#### ADDENDUM 1

ADDENDUM DATE: June 29, 2023

- PROJECT: Northwest Human Services Center 215 Balfour Drive Archdale, NC 27263
- OWNER: Randolph County 725 McDowell Road Asheboro, NC 27205
- ARCHITECT: Smith Sinnett Architecture, P.A. 4600 Lake Boone Trail, Suite 205 Raleigh, North Carolina 27607
- BIDS DUE: July 18, 2023 at 2:00pm Meeting Room A 725 McDowell Road Asheboro, NC 27205

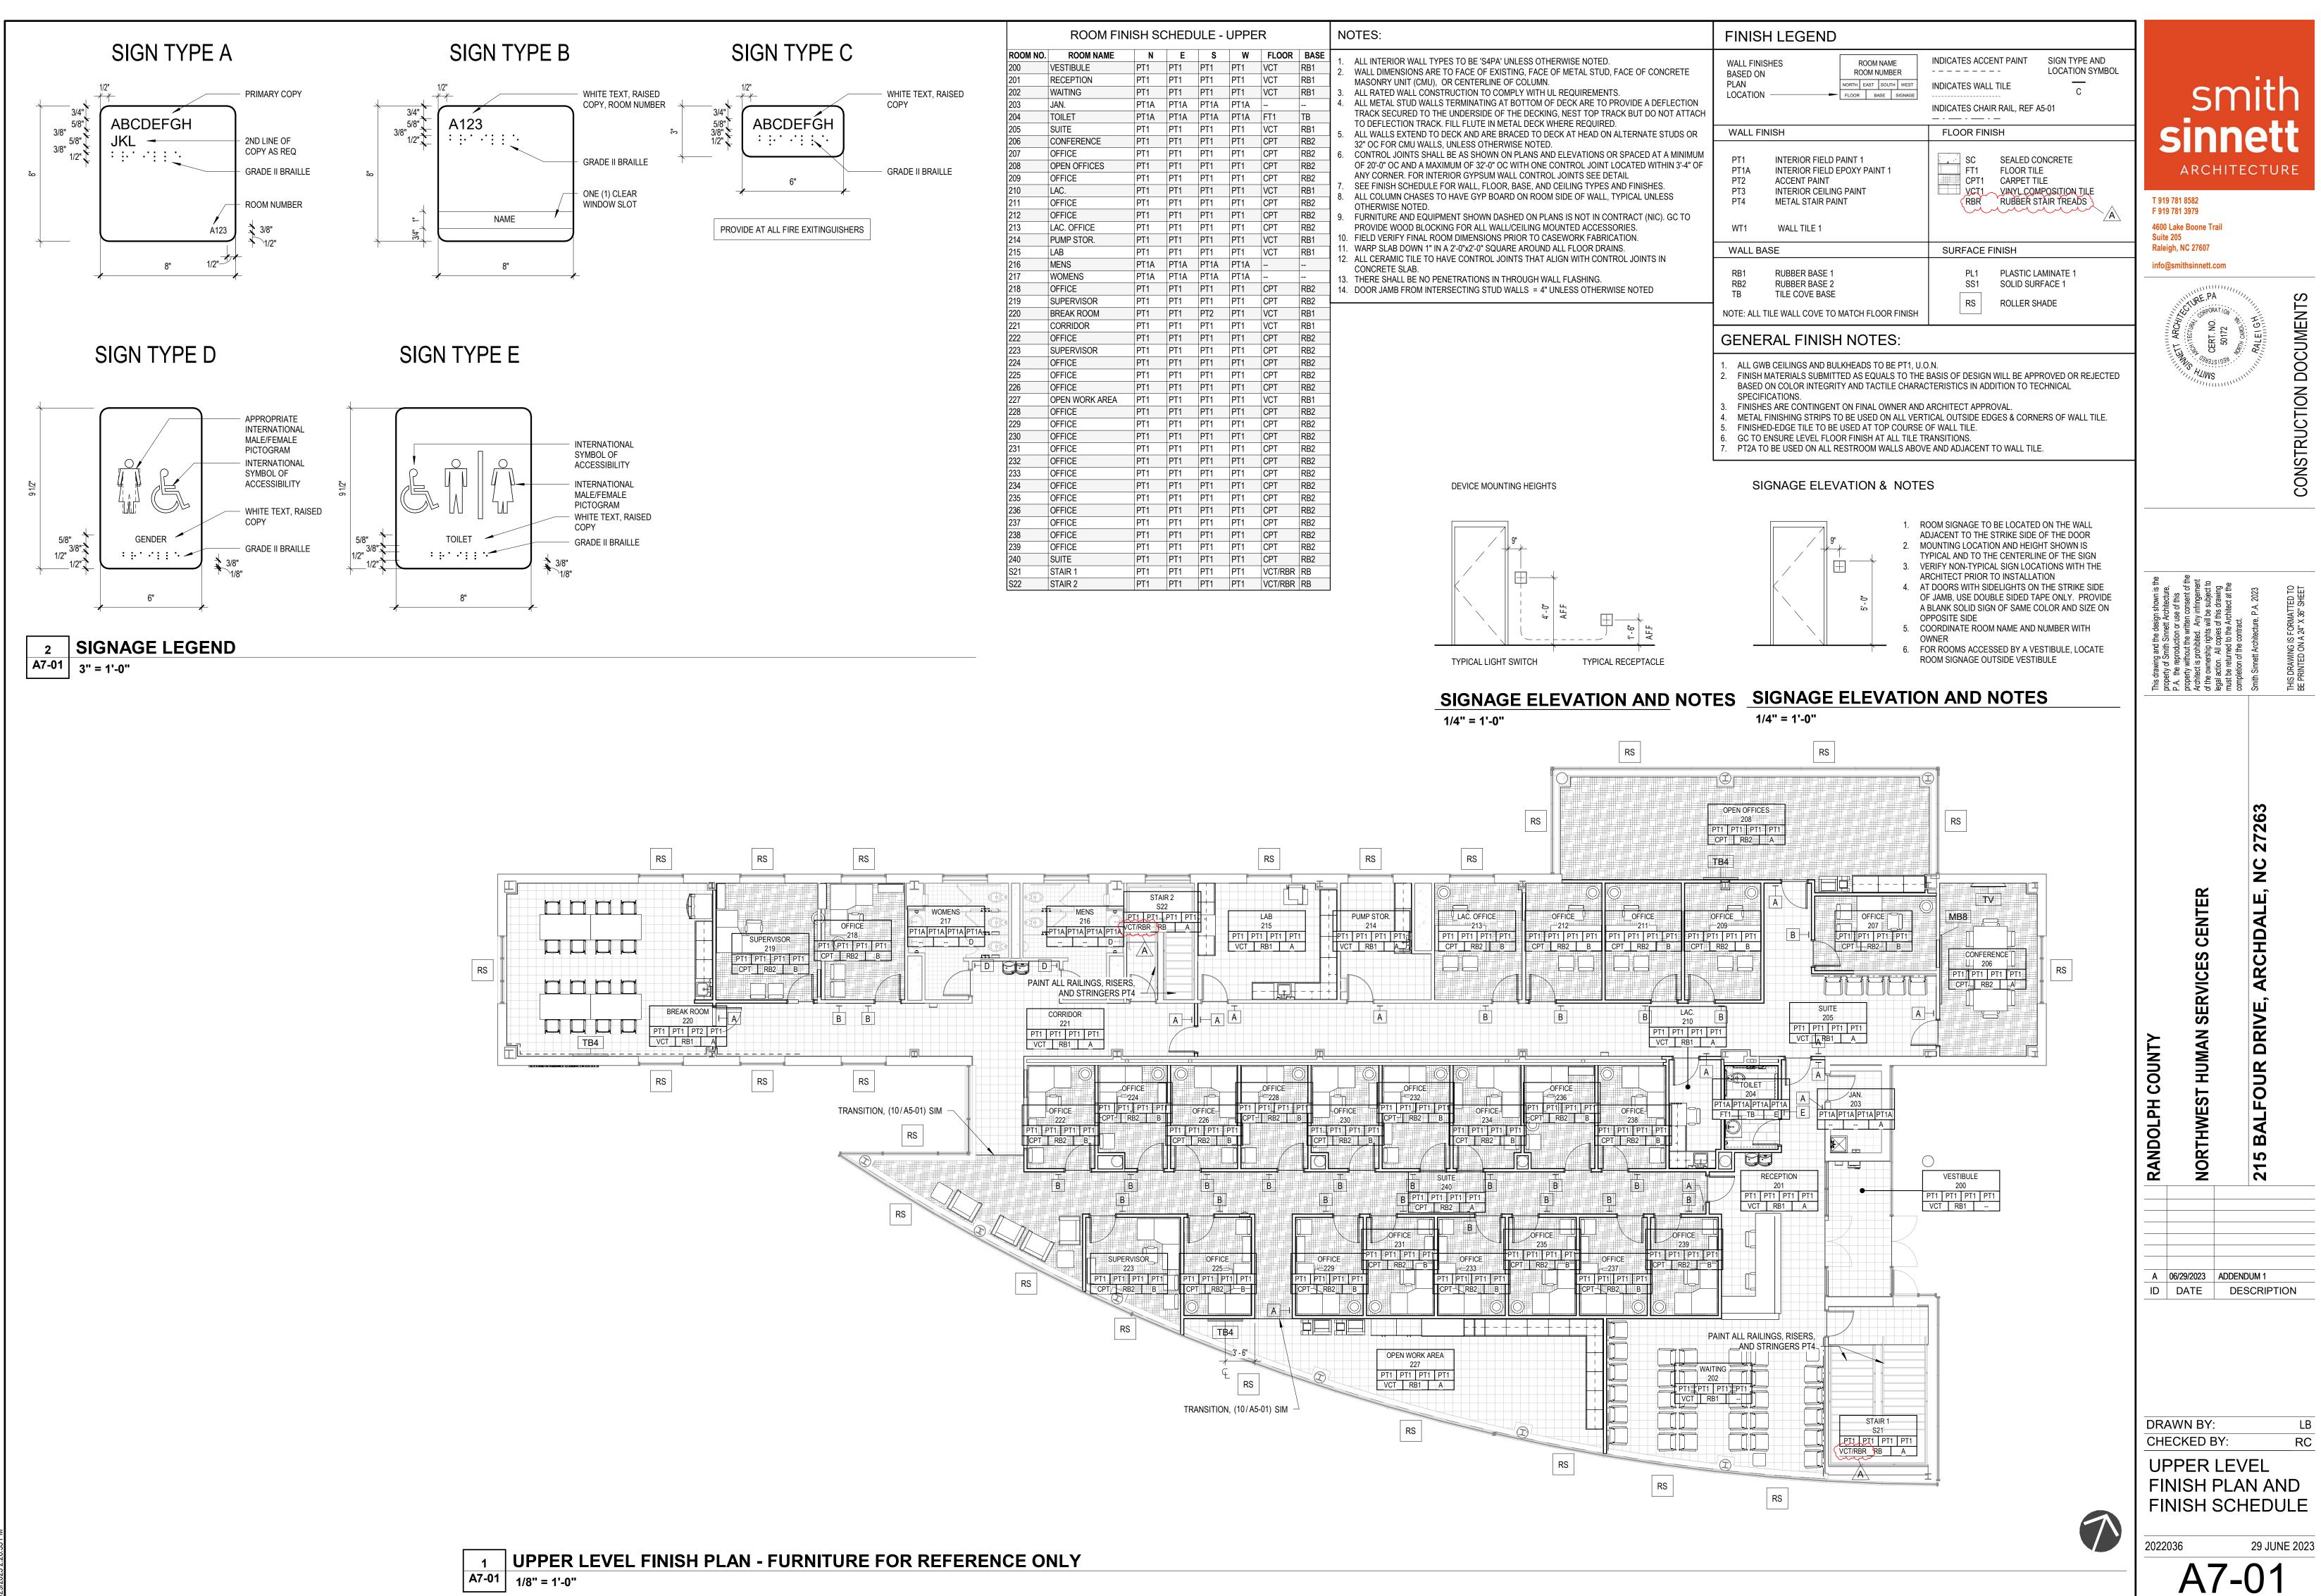
- 2. CLARIFICATION: A7-01 Stairwell floor finish replacement includes replacing existing rubber treads.
- 3. CLARIFICATION: A9-13 Stairwell floor finish replacement includes replacing existing rubber treads.
- 4. REVISION: A9-20 Parking stops added at existing retaining wall.
